STATE OF MAINE DEPARTMENT OF TRANSPORTATION 16 STATE HOUSE STATION AUGUSTA, MAINE 04333-0016

April 13, 2004

Project No's NH-0556(270)E,NH-0556(310)X,IM-0556(320)E, NH-1140(800)E & NH-1140(900)E

Bid Amendment No. 2

TIMBER GUARDRAIL EM 606 611

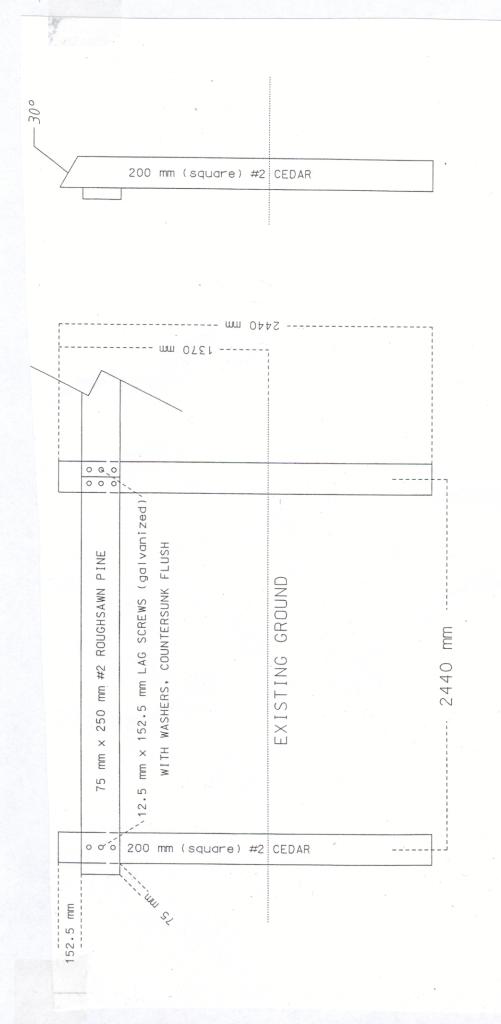
<u>Rails</u> Wood rail shall be constructed as shown on the enclosed detail. Rails shall be erected to result in a smooth continuous guardrail conforming to the line and grade as shown on the plans. Top of rail shall be flush with the top of supporting post and shall be set 0.9 mm [24 in] above finished grade. Butt adjoining rail sections; maximum separation between adjoining rail sections shall be 0.002 mm [1/16 in].
